EXTRACT FROM COUNCIL MEETING MINUTES OF OCTOBER 20, 2021

10. VAUGHAN BAPTIST CHURCH SITE DEVELOPMENT FILE DA.20.042 VICINITY OF TESTON ROAD AND WESTON ROAD

TITLE: VAUGHAN BAPTIST CHURCH
SITE DEVELOPMENT FILE DA.20.042
VICINITY OF TESTON ROAD AND WESTON ROAD

Site Plan and Landscape Plan

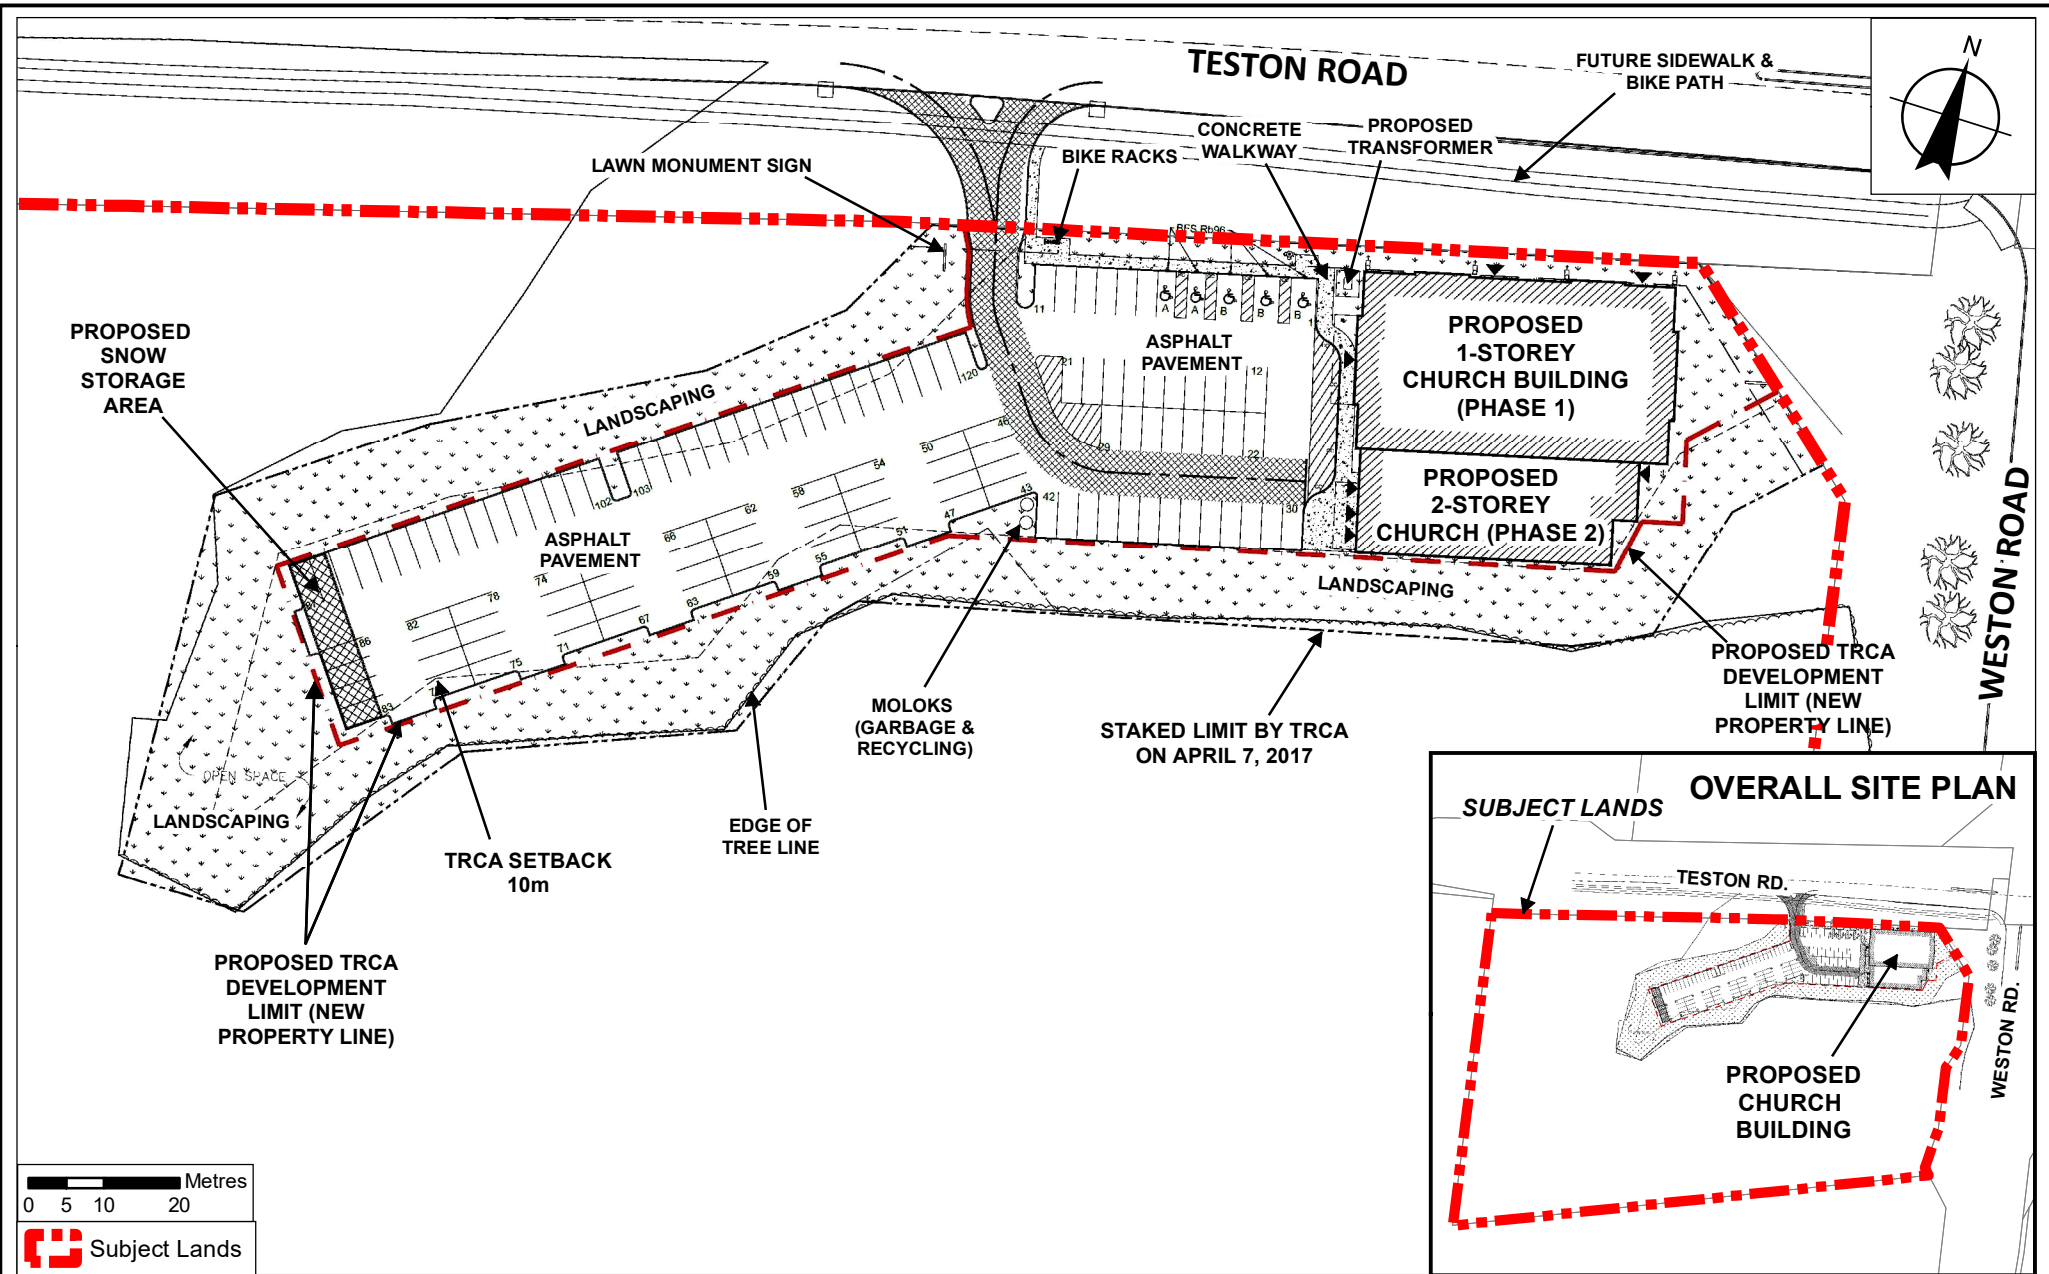
The Development shown on Attachment 3 proposes a 2-storey Church building to be constructed in two phases. Phase 1 consists of the main 1-storey Church building containing the foyer and sanctuary. Phase 2 proposes a 2-storey addition to the Church building containing classrooms and offices. The foyer from Phase 1 will be replaced with a gymnasium and will be relocated to the Phase 2 portion of the Church building. One vehicular access is proposed from Teston Road. There are a total of 114 parking spaces proposed, including 5 barrier free parking spaces. An additional 6 parking spaces are identified on the Site Plan as "snow storage area". These spaces are not included in the total 114 parking spaces as they may not be available in the winter months. A concrete walkway connects the main sidewalk on Teston Road to the entrances of the building. Additional pedestrian connections shall be provided, leading to entrances at the north and east side of the building. The boundary identified as "Proposed TRCA Development Limit (New Property Line)" shown on Attachment 3 shall be the new property boundary and the remainder of the Subject Lands are to be conveyed to the TRCA.

The Environmental Services Department has no objection to the proposed Molok system shown on Attachment 3, subject to the Owner providing details on the size of each Molok container to the satisfaction of the Environmental Services Department. A Condition to this effect is included in Attachment 1.

2. That the proposed access shall be limited to “right-in / left and right-out” access, which will be reflected on the final set of site plan drawings; and

Building Elevations (Phase 1)

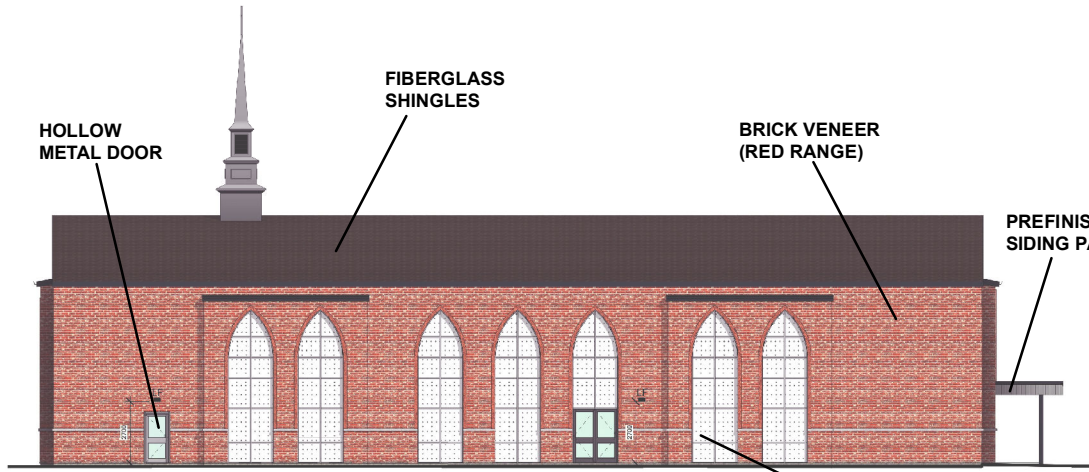
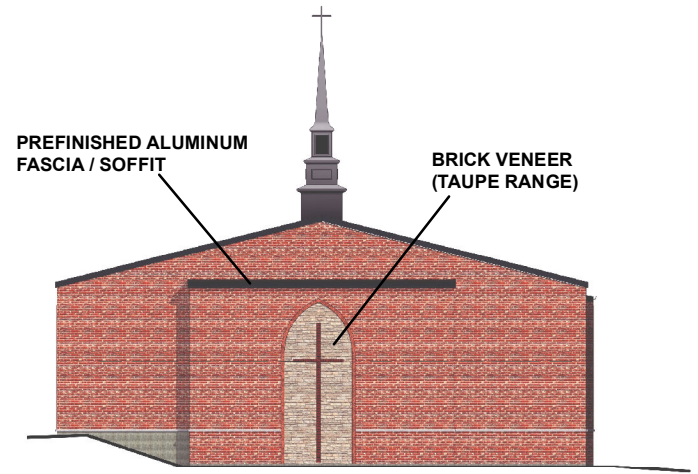
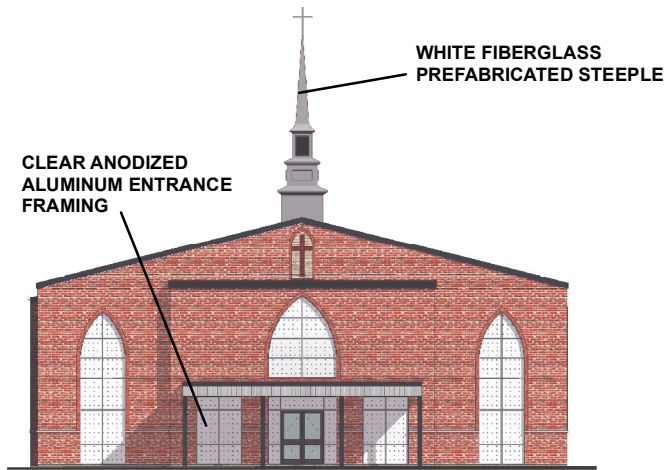
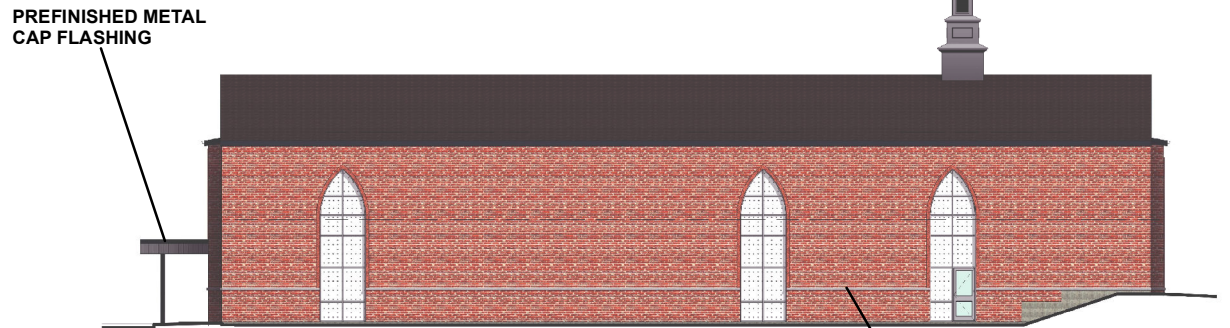
The building elevations shown on Attachments 4 and 5 will incorporate brick veneer in various colours, metal and aluminum siding panels, and fiberglass shingles. Bird friendly treatment and standard notes shall be annotated on the elevations. The final building elevations shall be approved to the satisfaction of the DP Department.

**Signage Details and
Elevations**

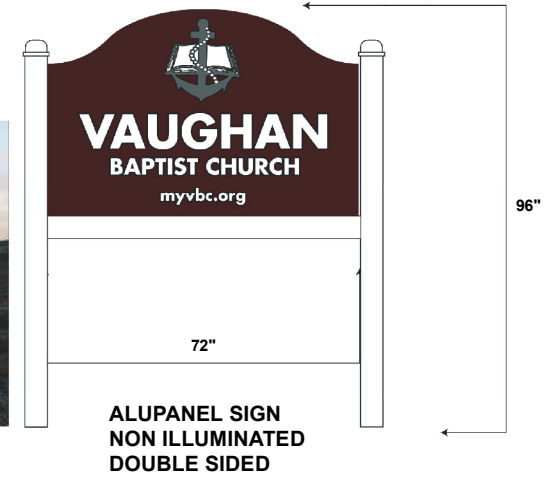
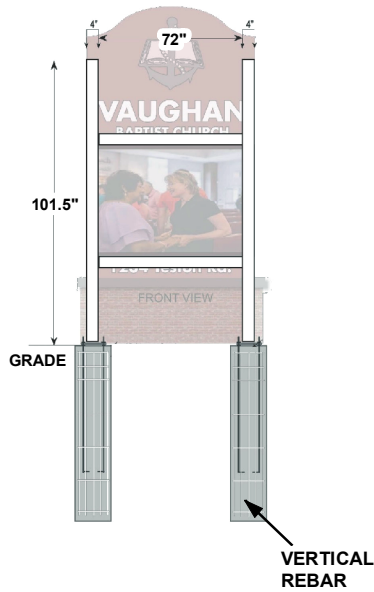
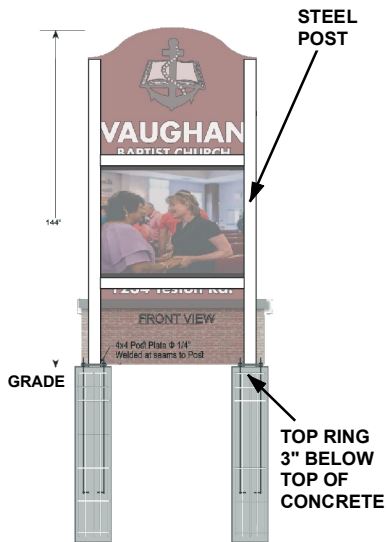
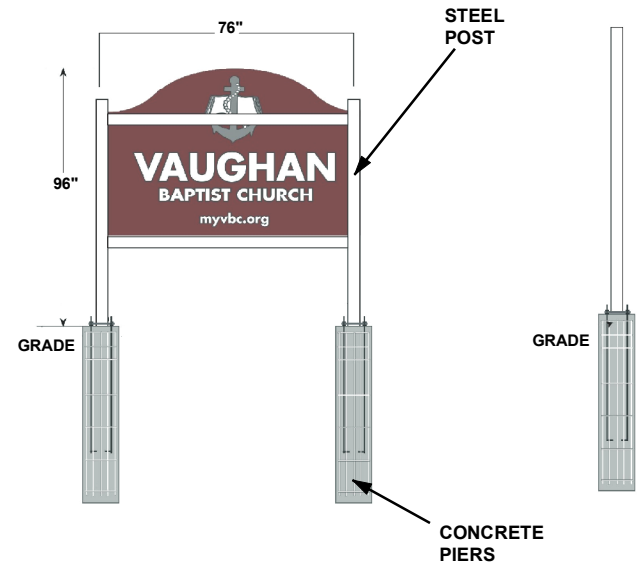
The proposed Site Signage drawings are shown on Attachment 6. All dimensions on the drawings shall be in metrics and an annotation shall be added to state that illumination values will range at maximum 300nits sunset to sunrise and at maximum 500nits sunrise to sunset.
